ARCHITECT'S ADDENDUM

Addendum Number: 03

RE: EAHS 2026 Secured Entrance

Subject: Addendum 03 to the Construction Documents for the East Aurora High School 2026 Secured Entrance Project.

1 FIRST FLOOR - MAIN ENTRANCE NEW WORK PLAN - AREA B
1/8" = 1'-0"

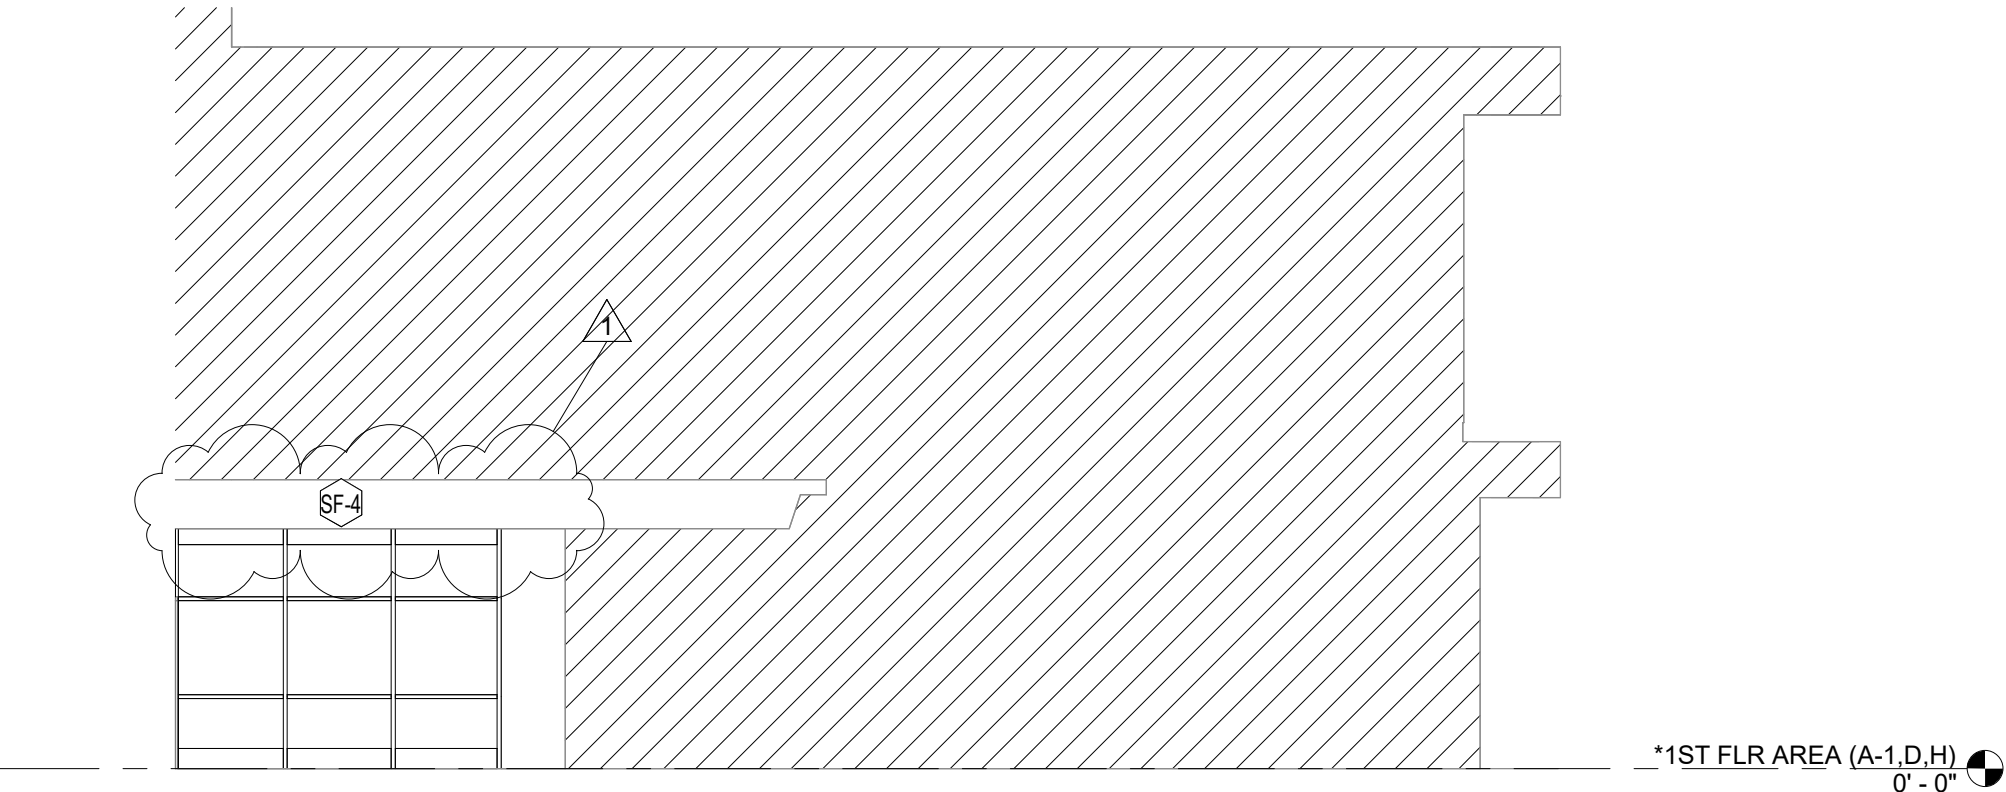
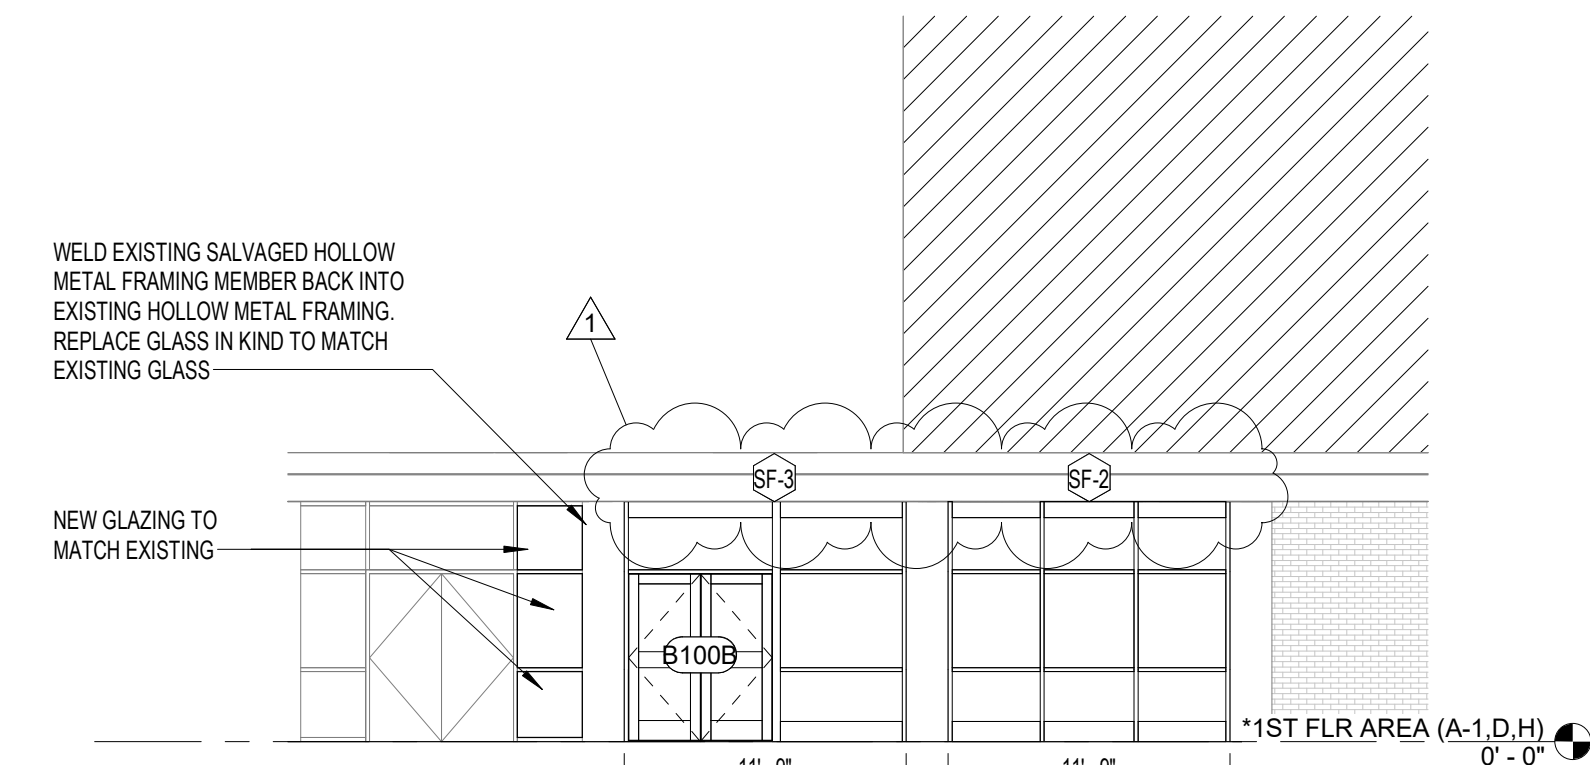
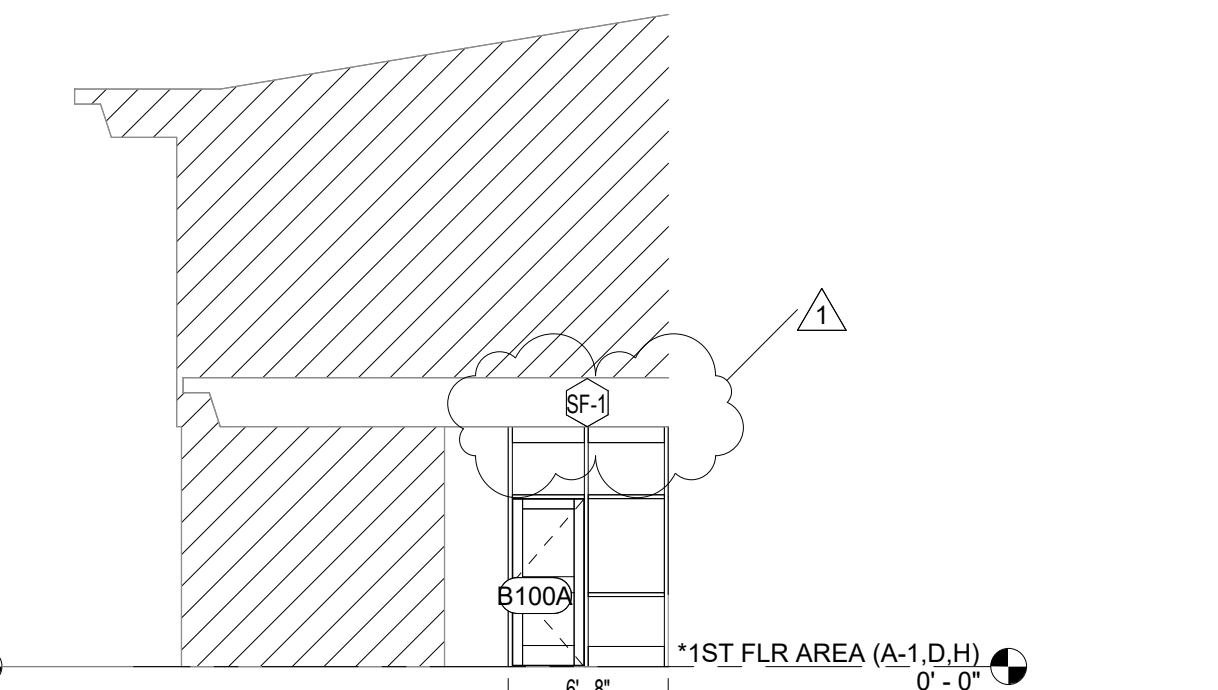
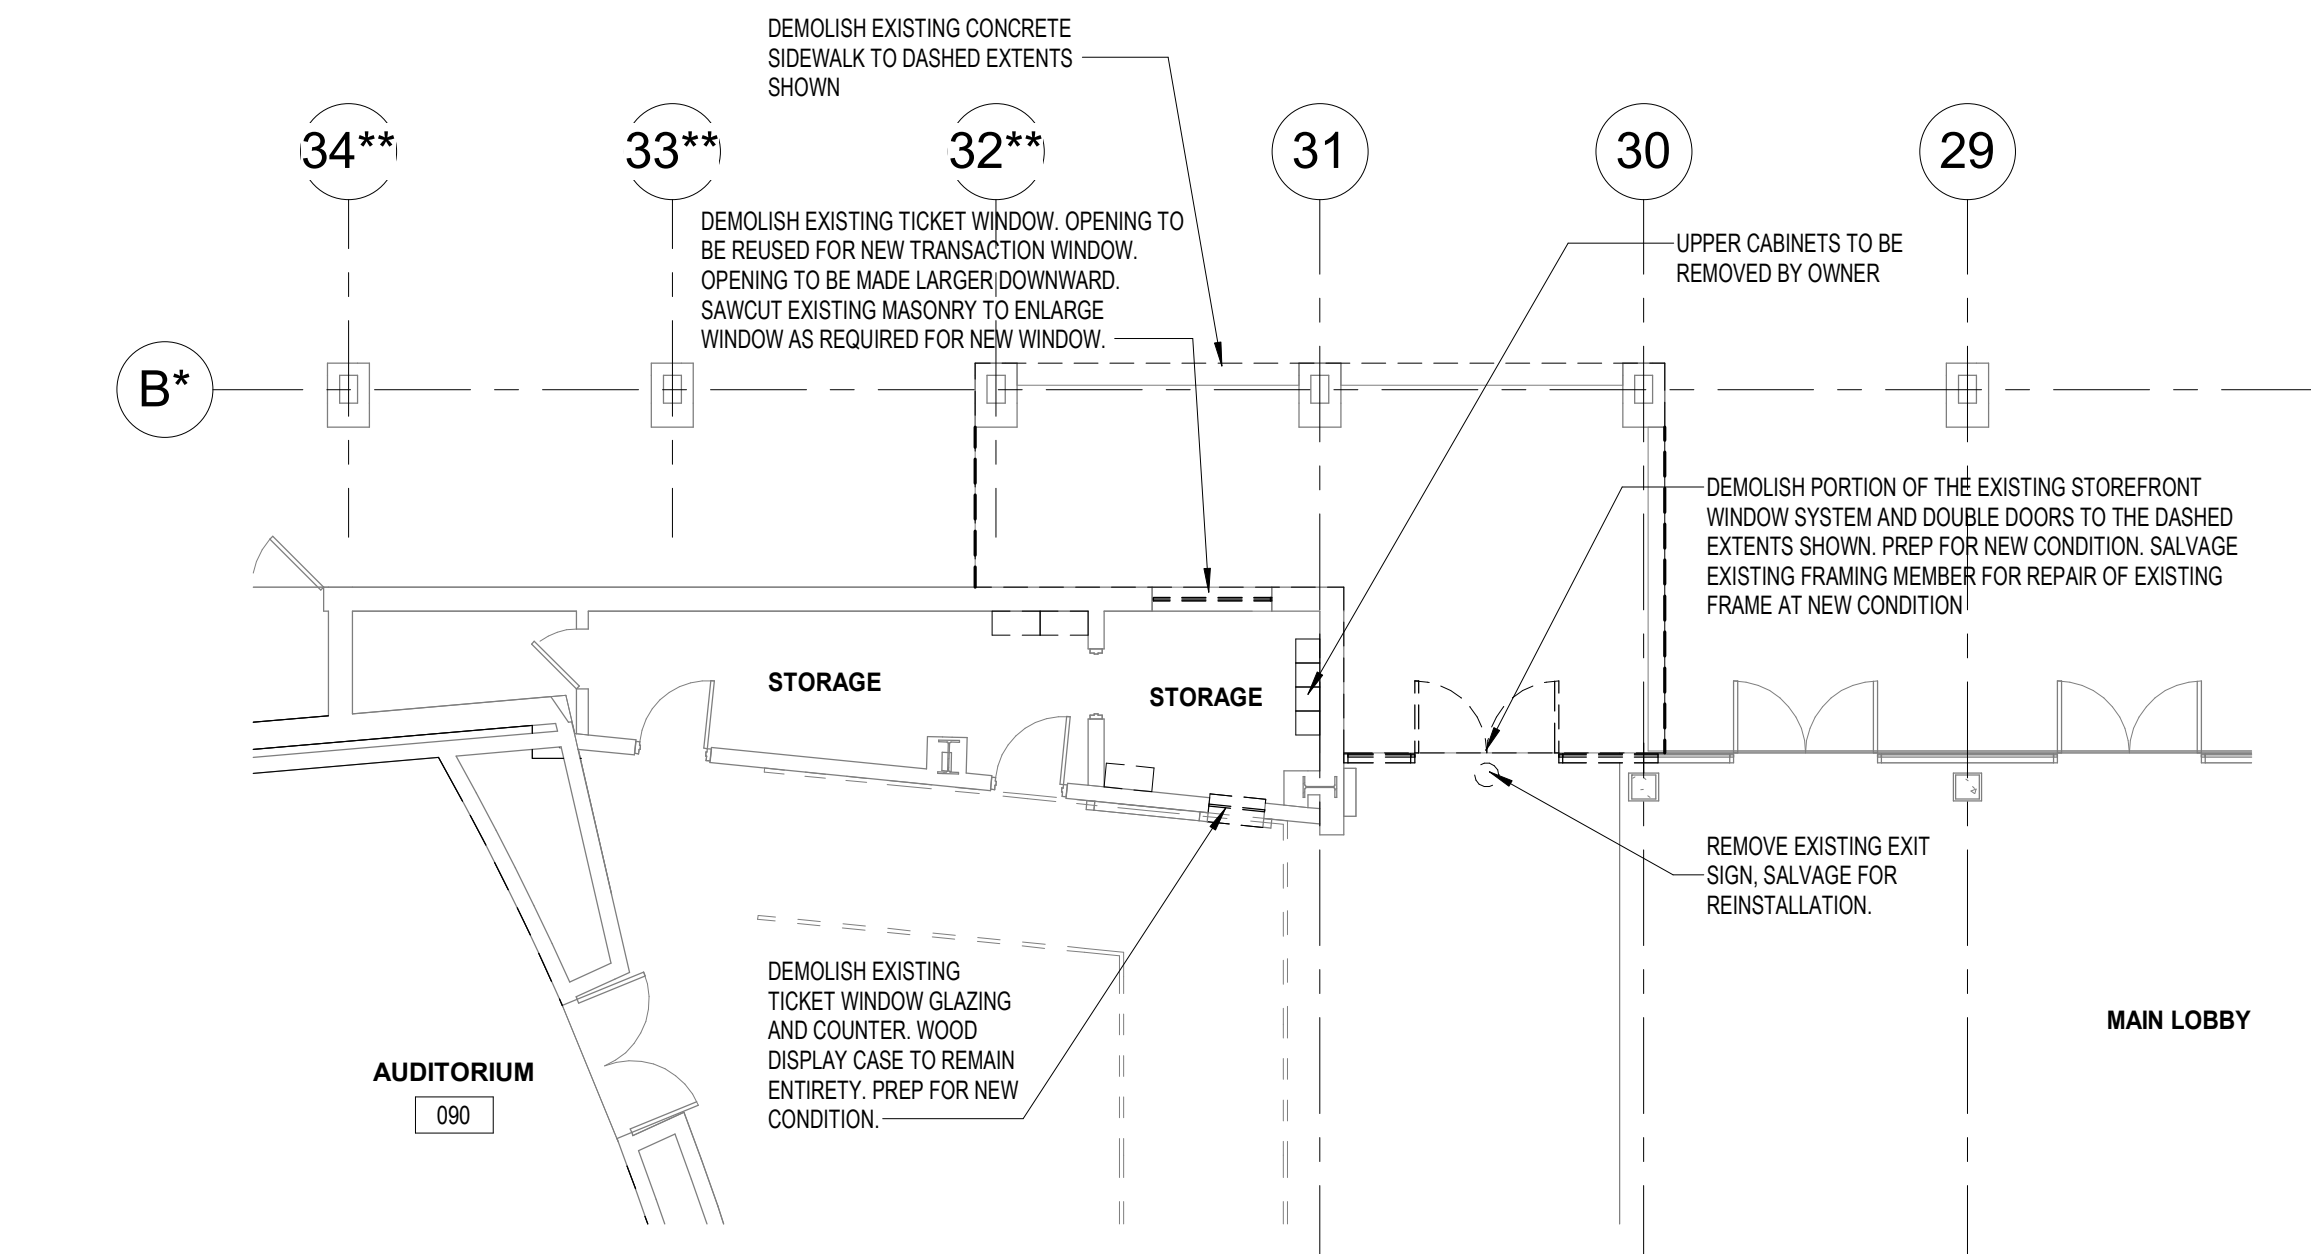
- 1) Sheet A1.00 – Partial First Floor Plan – Area B
 - **REVISED** Existing Conditions Photograph, Elevations, and New Work Plan. Refer to clouded regions on the attached drawing sheet.
- 2) Sheet A2.00 – Interior Elevations, Storefront Elevations, Wall Types, & Details
 - **REVISED** Glazing Notes and Legend, Alternate Descriptions, Storefront Elevations, and Detail 5 – Typical Header Detail – Main Entrance. Refer to clouded regions on the attached drawing sheet.
